INCH-POUND
MIL-PRF-22885/111(EC)
AMENDMENT 2
1 July 1997
SUPERSEDING
AMENDMENT 1
10 May 1996

PERFORMANCE SPECIFICATION SHEET

SWITCHES, PUSHBUTTON, LIGHT EMITTING DIODE (LED) ILLUMINATED, STANDARD, NIGHT VISION IMAGING SYSTEM (NVIS) AND SUNLIGHT READABLE DISPLAYS, SPDT AND DPDT, LOW LEVEL TO 7 AMPERES, SEALED AND UNSEALED, SOLDER AND COMMON TERMINATION SYSTEM (CTS) TERMINATIONS

SEAL CROSS SECTIONAL VIEW

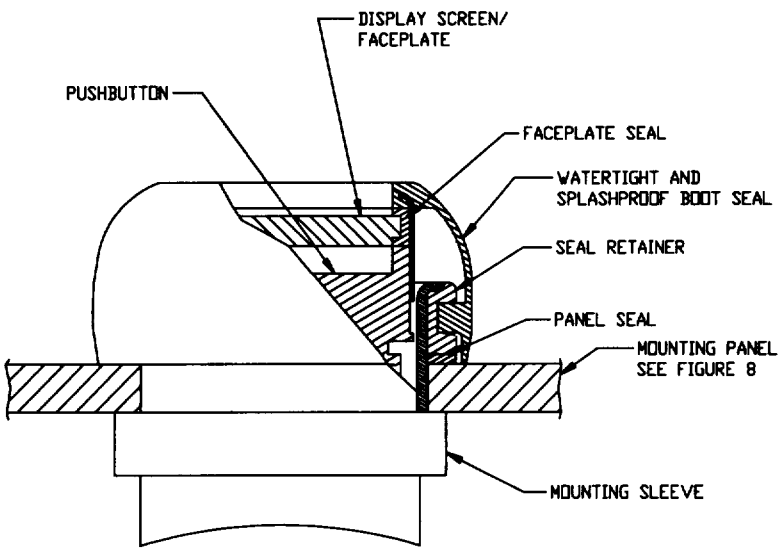
FIGURE 2, seal cross sectional view: Delete and substitute:
